ADDENDUM NO. 5
NEW SOFTBALL COMPLEX FOR TRUSSVILLE CITY SCHOOLS
Architect Job No. 23-72
April 17, 2024
DCM # 20240224

The Plans and Specifications are here by amended. The following supersedes all contrary and/or conflicting information and is made part of the contract documents.

JOB NO. **23-72**
SHEET NO:
E6.1
9 OF 9

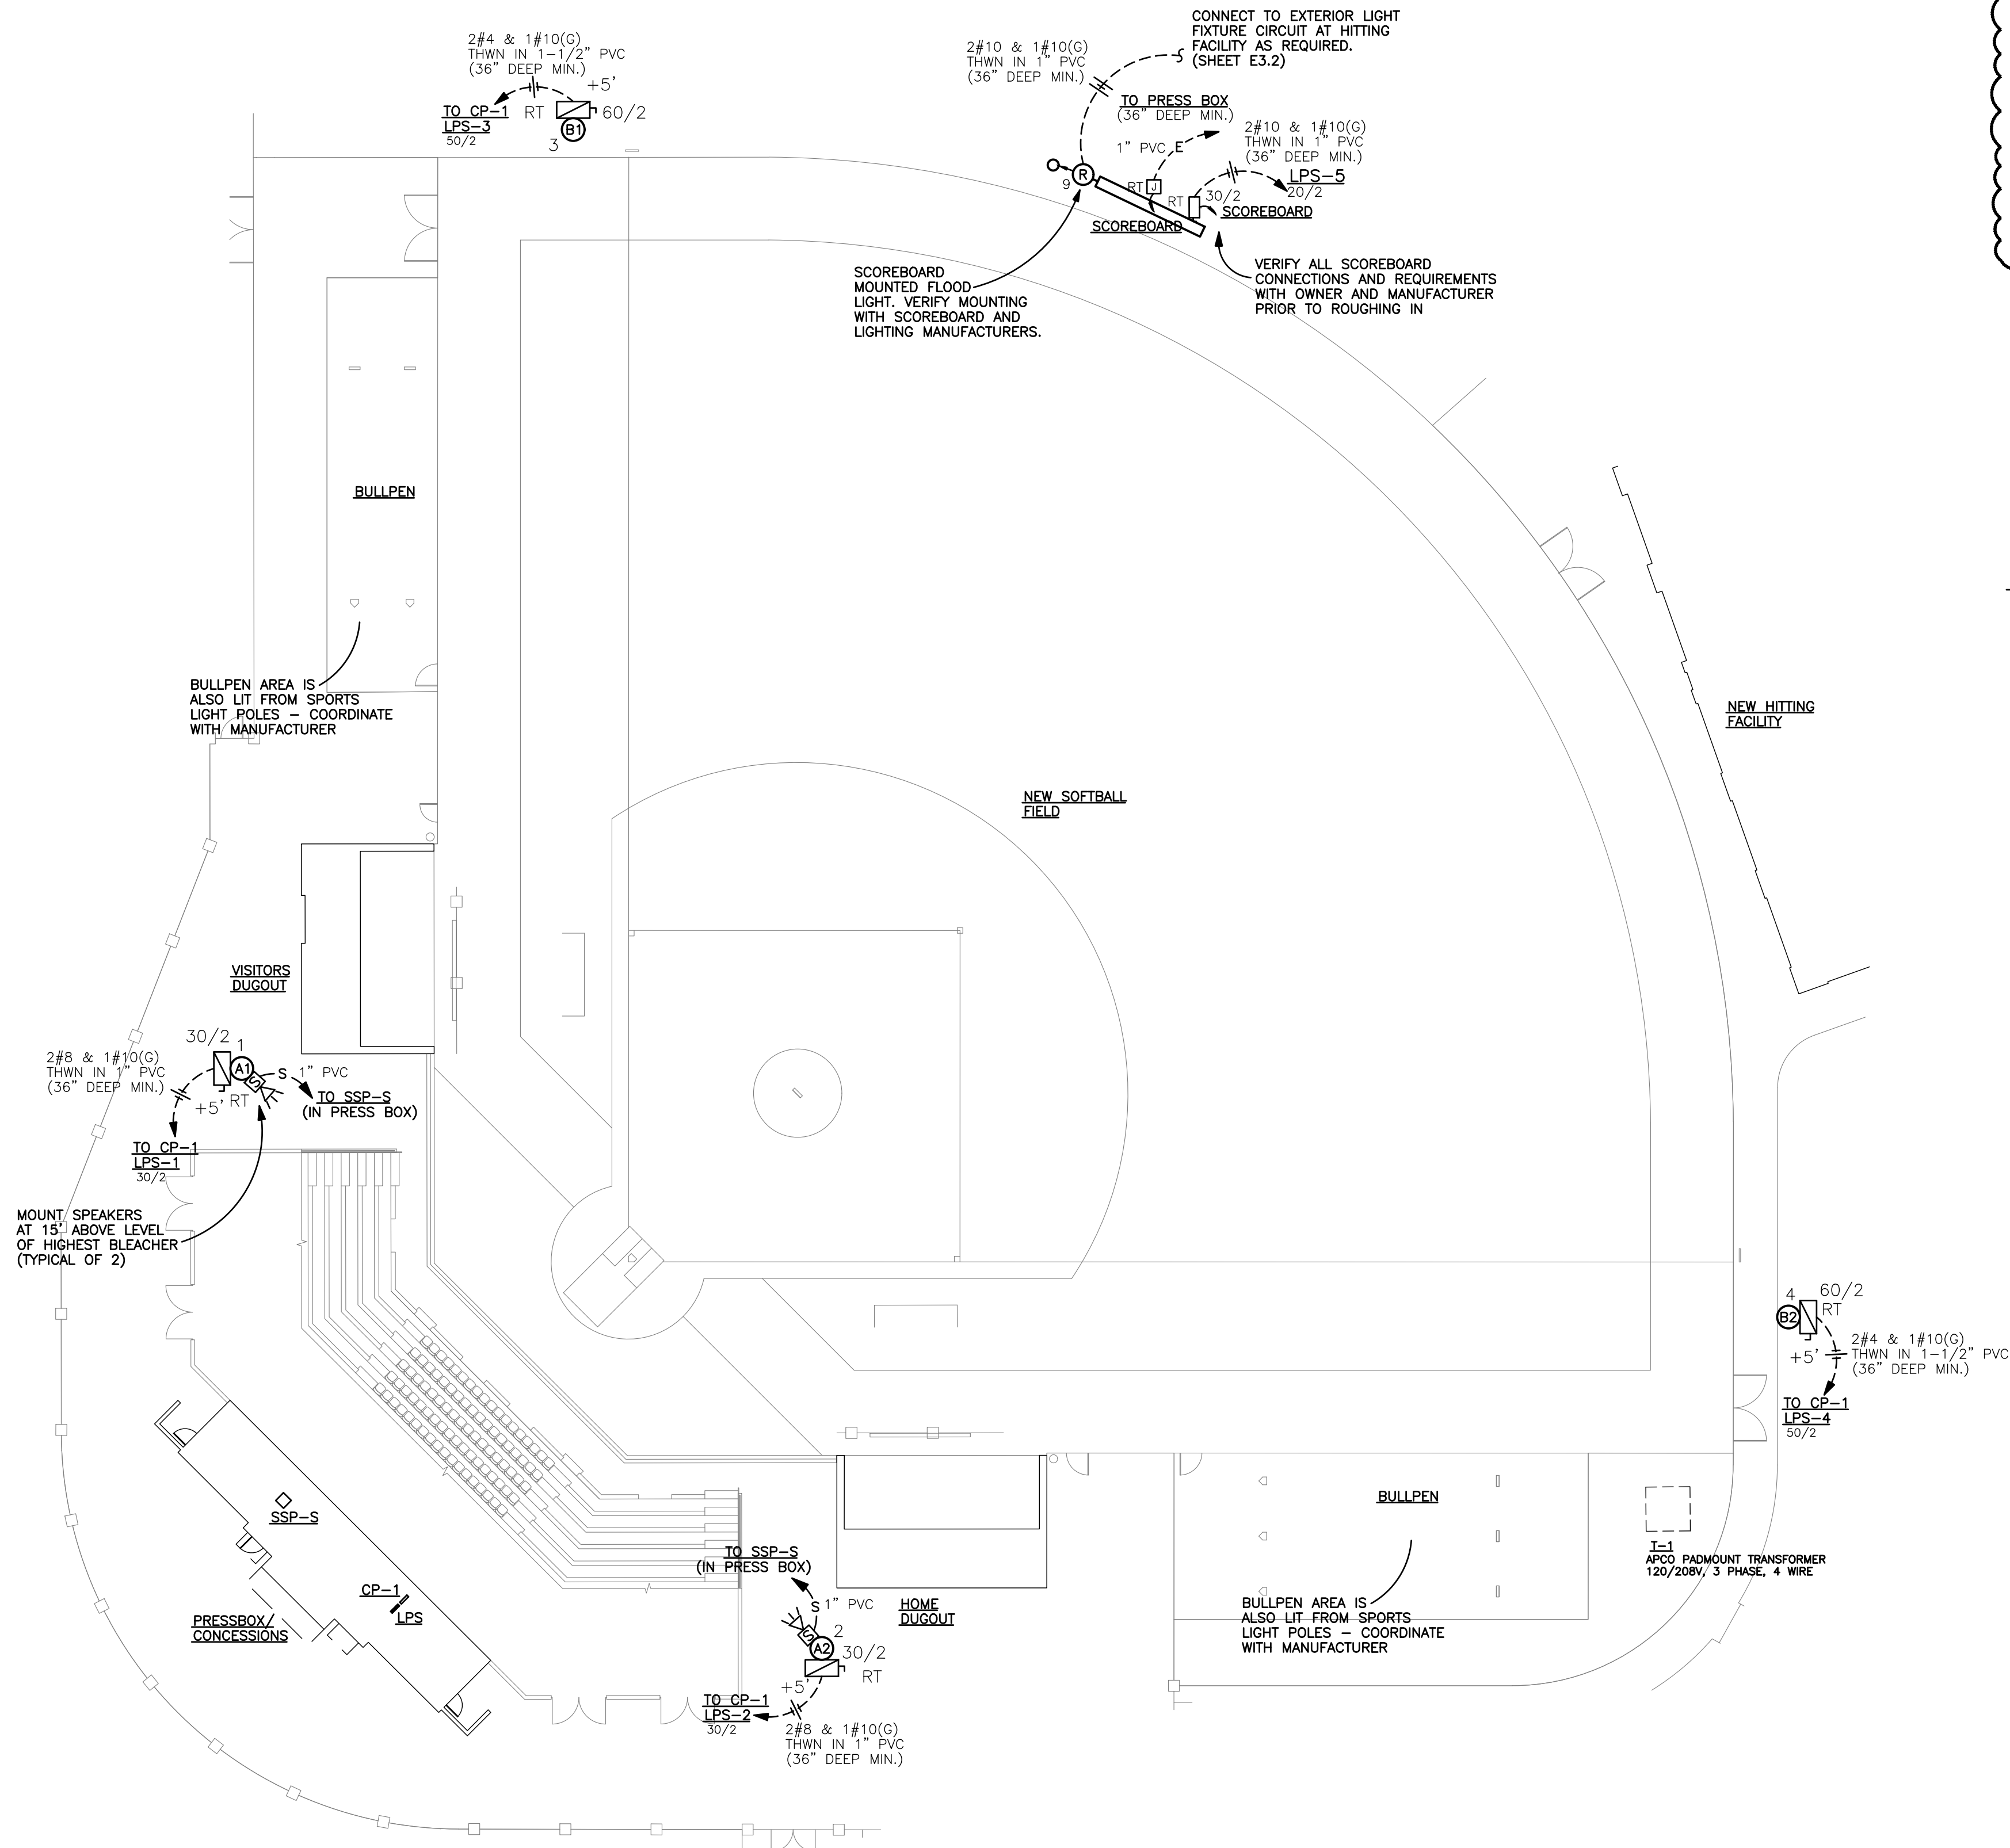
5. See the attached REVISED Sheet **A3.1** for revisions to Concessions / Bleacher Elevations adding building signage.
6. See the attached REVISED Sheet **A3.2** for revisions to Locker Room / Hitting Facility Elevations adding building signage.
7. See the attached REVISED Sheet **S2.2** for revisions to Press Box Foundation and Upper Framing Plan.
8. See the attached REVISED Sheet **S2.3** for Press Box Roof Framing Plan.
9. See the attached REVISED Sheet **E1.1** for revisions to Schedules, Symbols, and Notes.
10. See the attached REVISED Sheet **E2.1** for revisions to Site Plan and Single Line Diagram.
11. See the attached REVISED Sheet **E3.1** for revisions to Floor Plans – Lighting.
12. See the attached REVISED Sheet **E4.2** for revisions to Floor Plans – Power.
13. See the attached REVISED Sheet **E6.1** for revisions to Softball Field Lighting Plan.
